Planned Unit Development – Bear Creek

**CITY OF LA VISTA
PLANNING DIVISION
RECOMMENDATION REPORT**

CASE NUMBERS: PPUD23-0006; PCUP23-0010; PRP23-0004
FOR HEARING ON: JUNE 6, 2024; REPORT PREPARED ON:
MAY 30, 2024, REPORT REVISED ON JUNE 6, 2024

PUD Site Plan

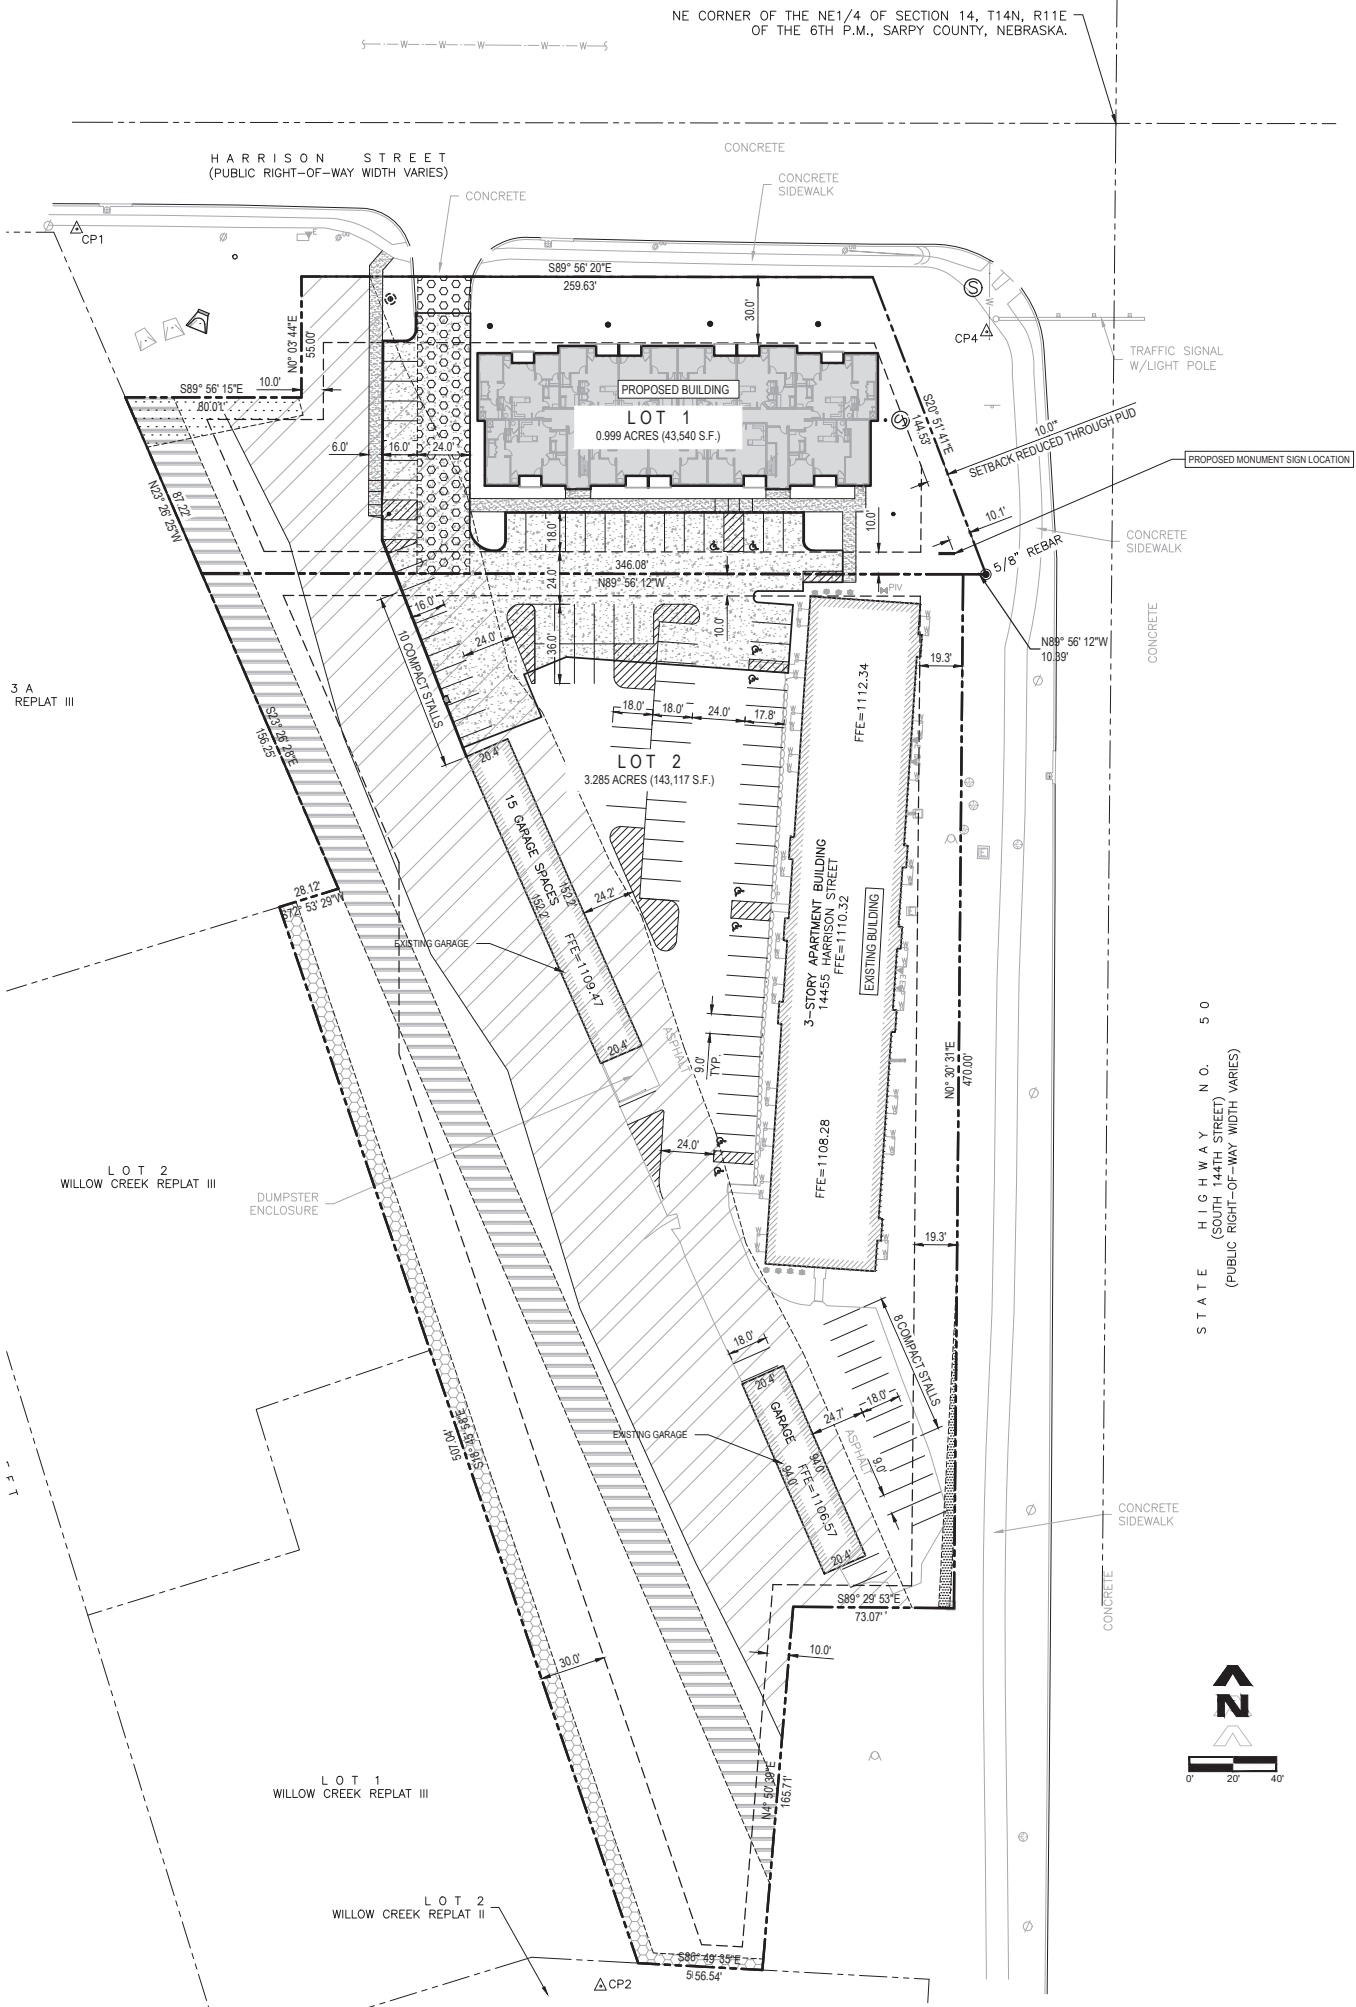
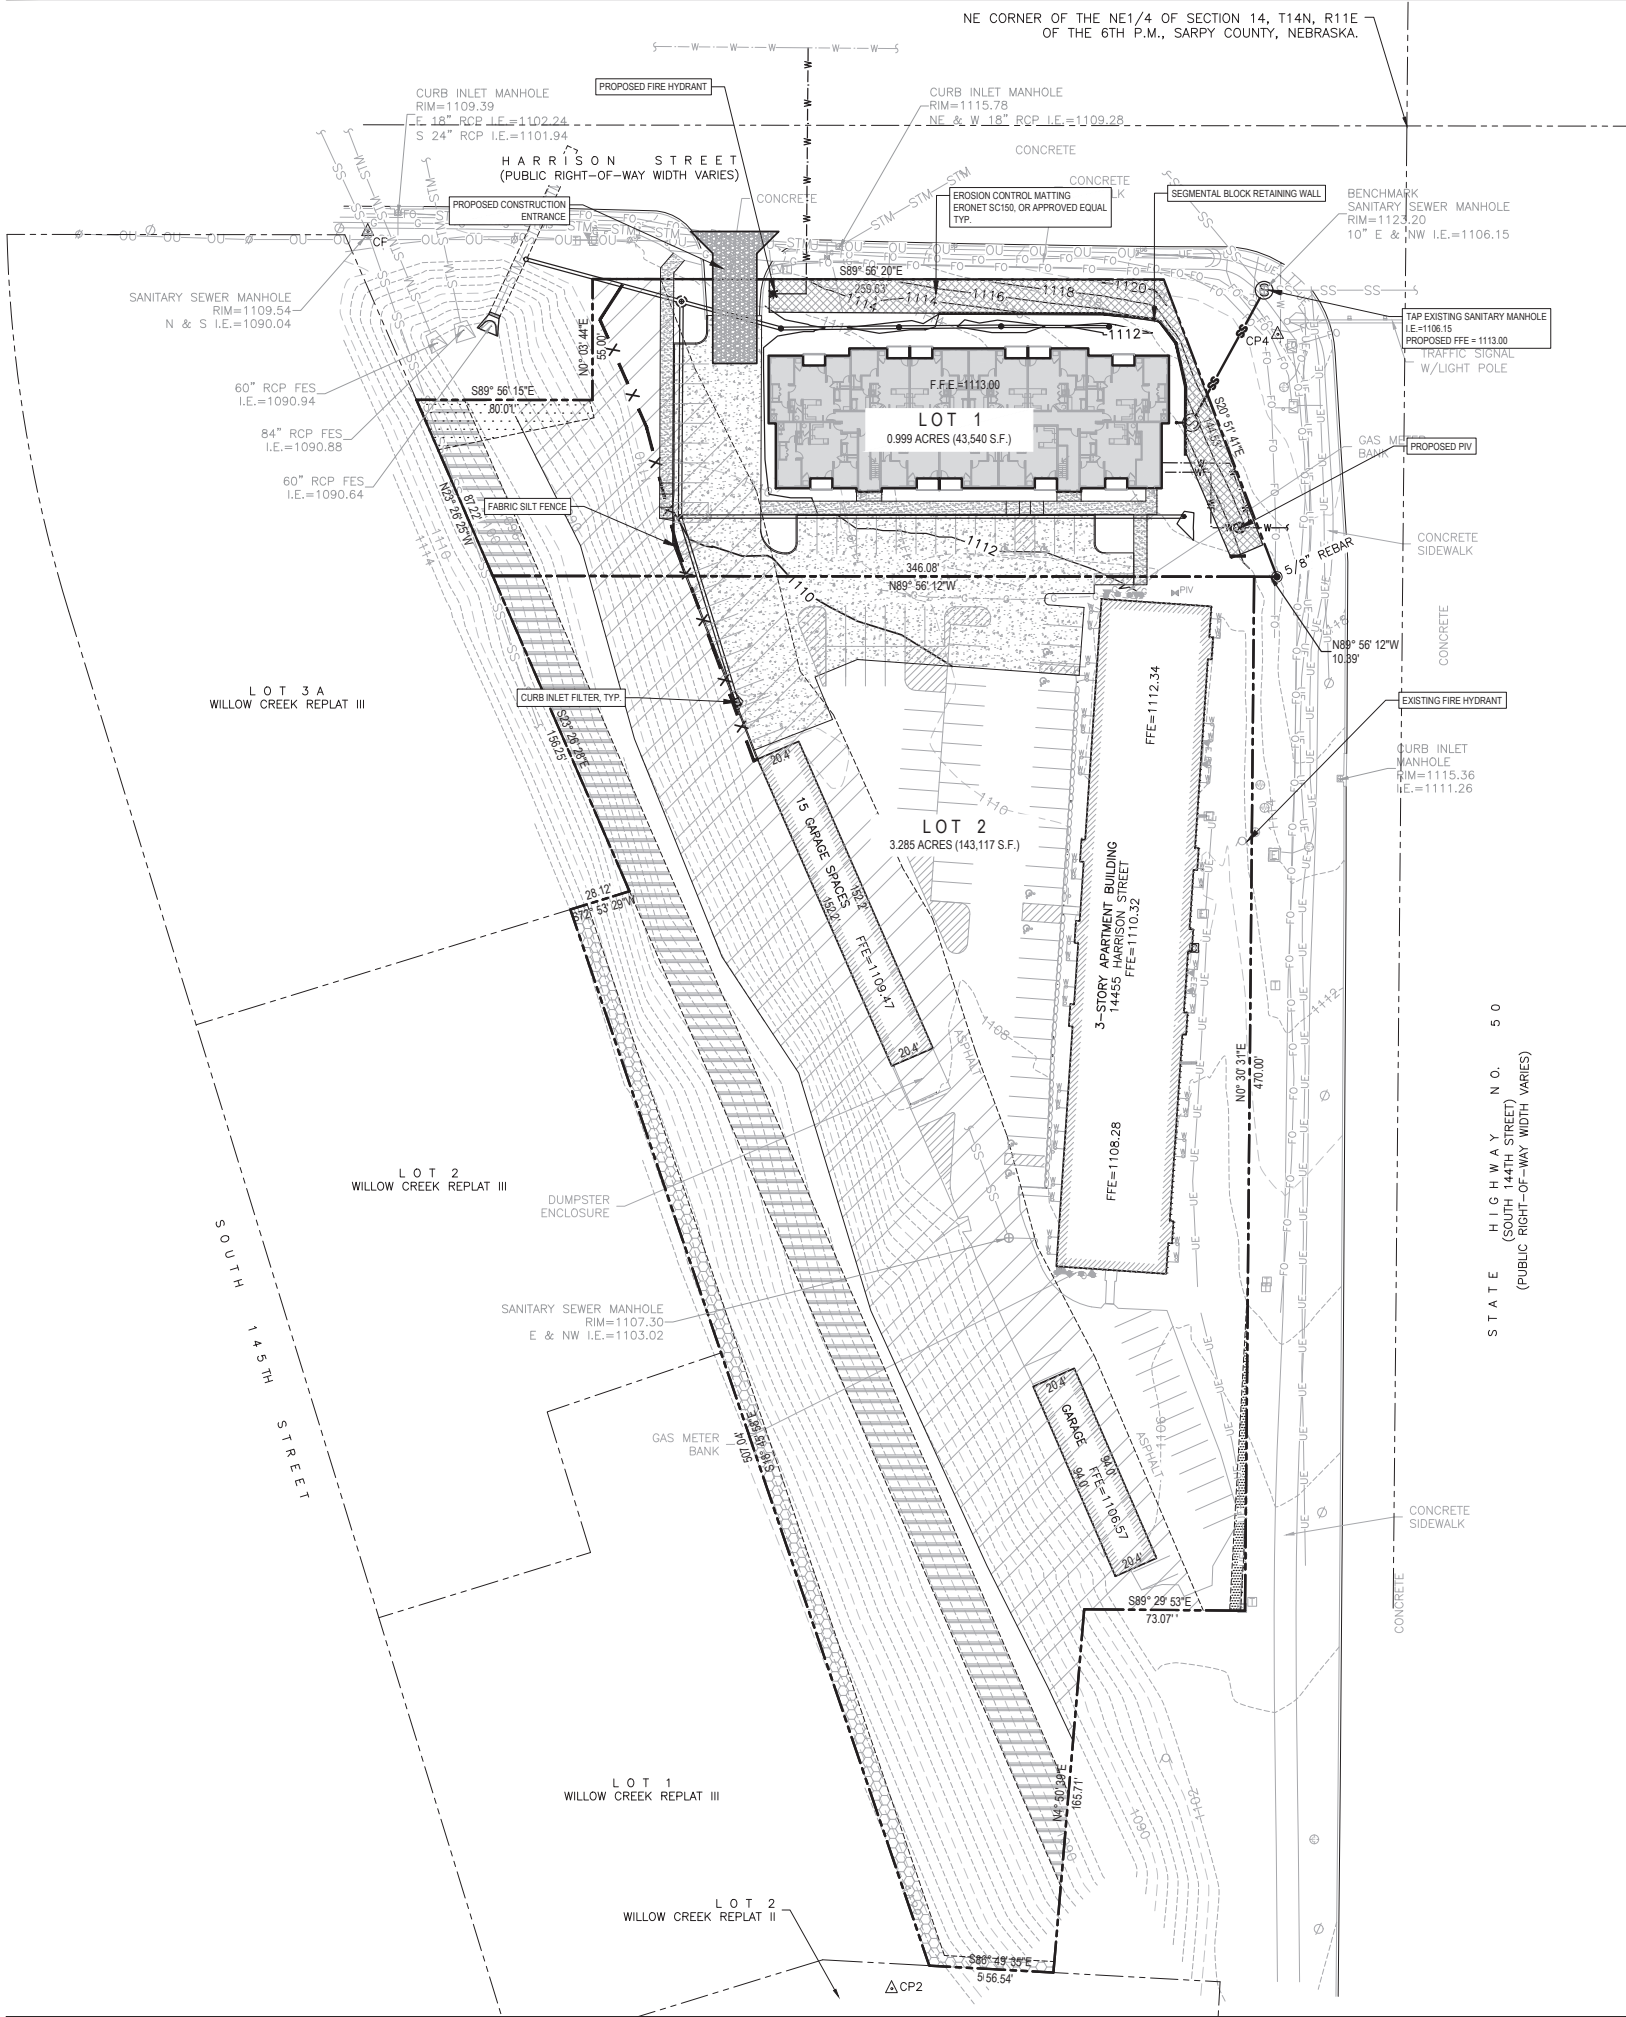
9. Please include the dimensions for the north side yard setback for the existing building on proposed lot 2 in the PUD plan set.
10. Where you are requesting reduced setbacks through the PUD (i.e. the reduced front yard setbacks along 144th Street, and the reduced north side yard setback for the building on proposed Lot 2), please add a note stating "___' setback reduced through PUD" on the PUD site plan.

11. Regarding Section 5.15.05.03.06, please provide dimensions of the off-street parking, inclusive of alley widths.

9. Please include the dimensions for the north side yard setback for the existing building on proposed lot 2 in the PUD plan set.
Setback dimensions have been added to the Site Plan.

10. Where you are requesting reduced setbacks through the PUD (i.e. the reduced front yard setbacks along 144th Street, and the reduced north side yard setback for the building on proposed Lot 2), please add a note stating setback reduced through PUD" on the PUD site plan.
Setback reduction notes added to the Site Plan.

11. Regarding Section 5.15.05.03.06, please provide dimensions of the off-street parking, inclusive of alley widths.
Dimensions have been added to the PUD Site Plan.

PUD Grading and
Utility Plan

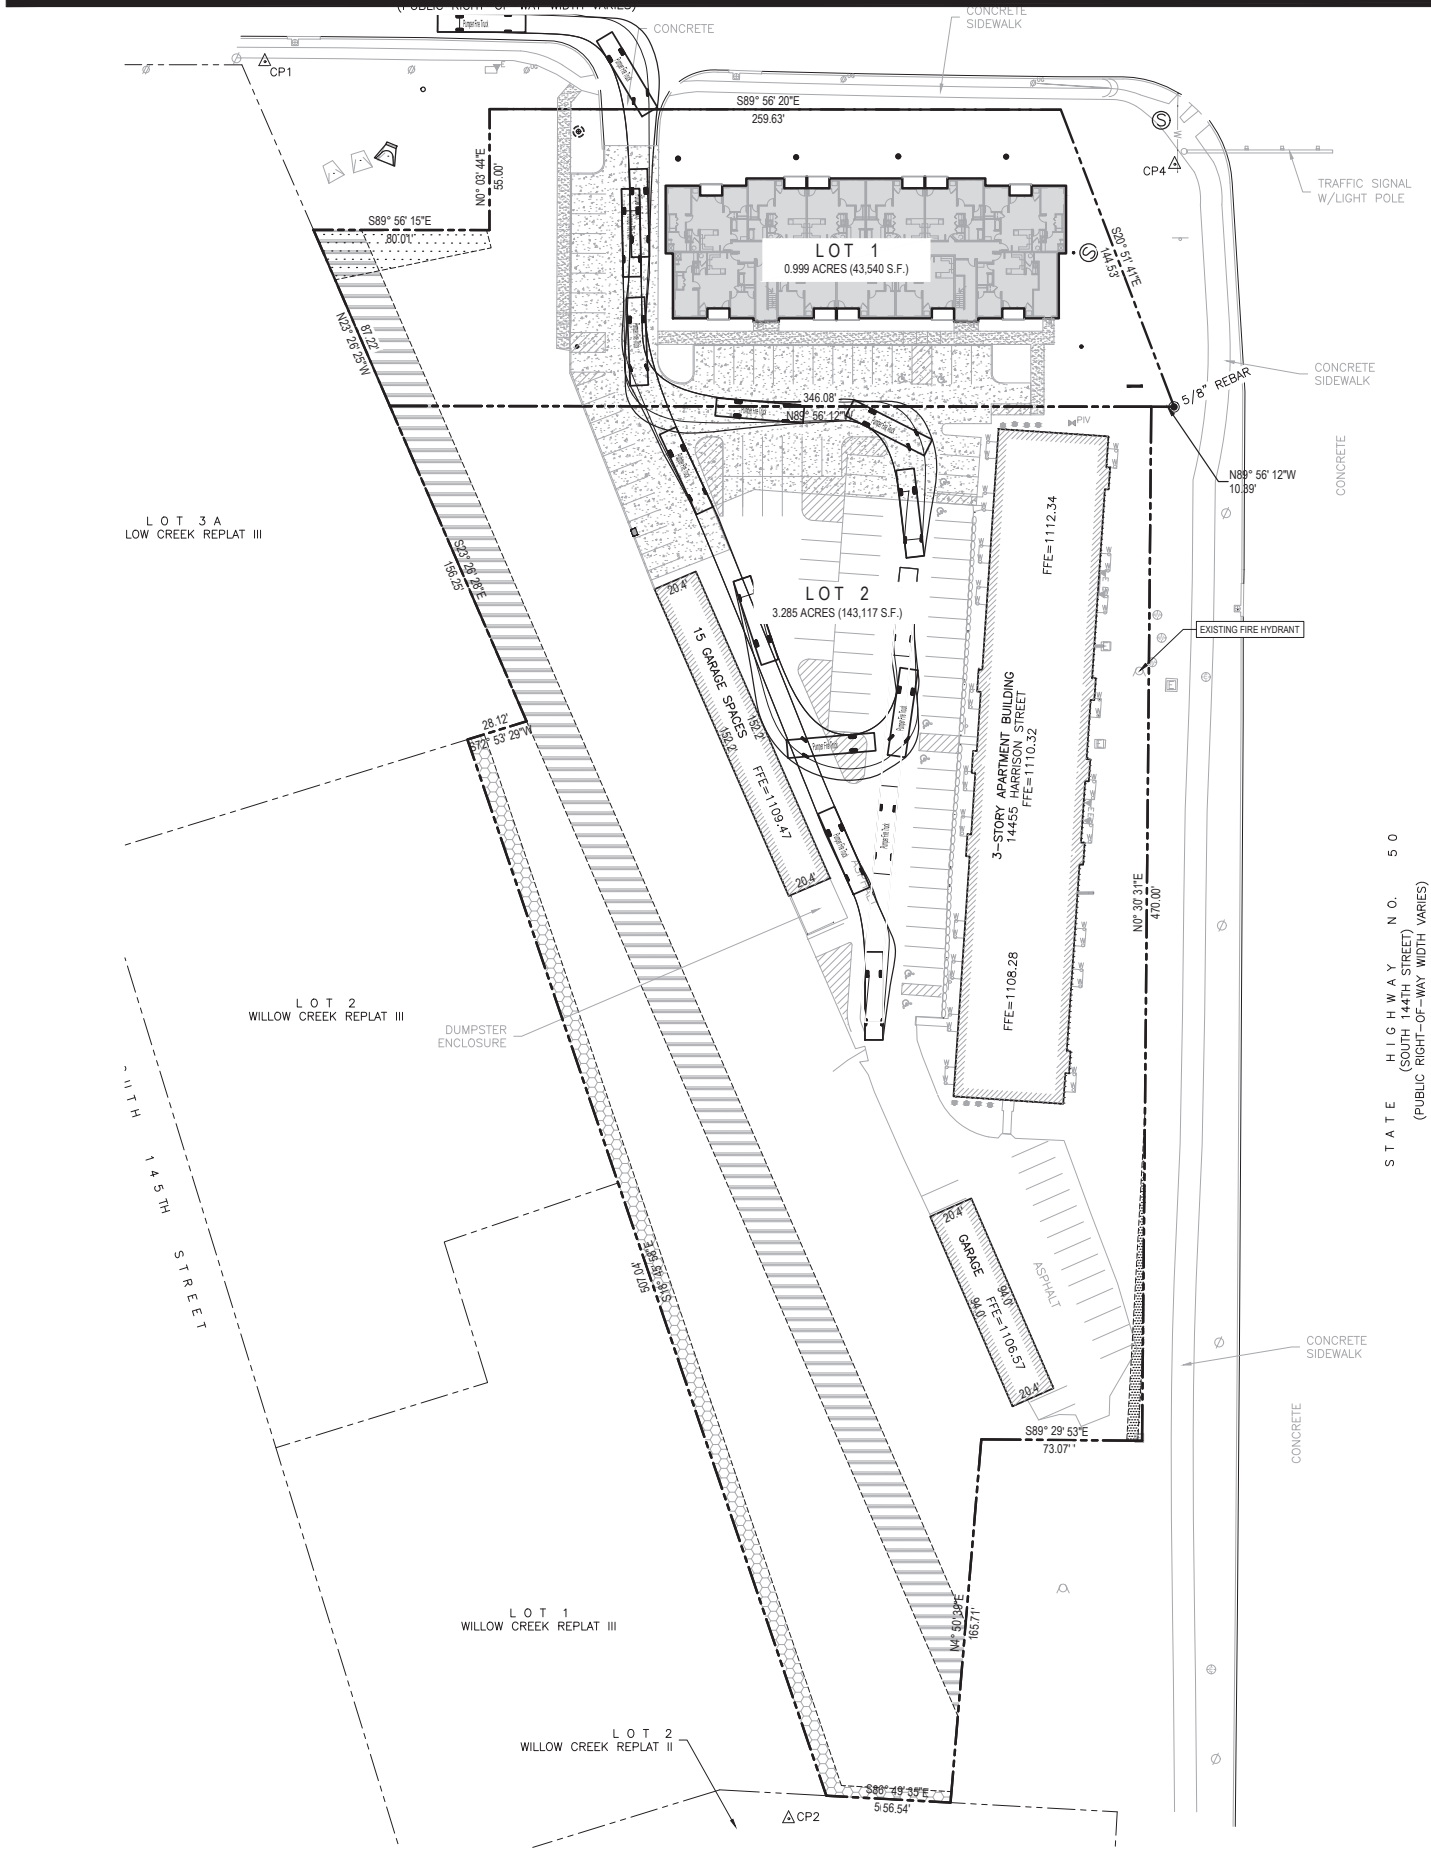
12. Regarding Section 5.15.05.04, please provide details on the point of connection and other pertinent design information for the sanitary sewer.
13. Regarding Section 5.15.05.07, please provide a rendering of the proposed buildings, inclusive of elevations and other applicable pertinent information.

14. Regarding Section 5.15.05.09, please provide copies of any restrictive covenants that exist on the property.
15. Additional fire hydrants serving the property are to be required per the Fire Inspector with the Papillion Fire Department. Please identify the location(s) for additional hydrants on the PUD plans.

12. Regarding Section 5.15.05.04, please provide details on the point of connection and other pertinent design information for the sanitary sewer.
Proposed sanitary sewer plan is to tap the existing sanitary manhole at the intersection of 144th & Harrison Street. The sewer tap will be in accordance with the City of Omaha Standard Plate 700-02.

15. Additional fire hydrants serving the property are to be required per the Fire Inspector with the Papillion Fire Department. Please identify the location(s) for additional hydrants on the PUD plans.
A new fire hydrant has been added and identified on the PUD Utility Plan.
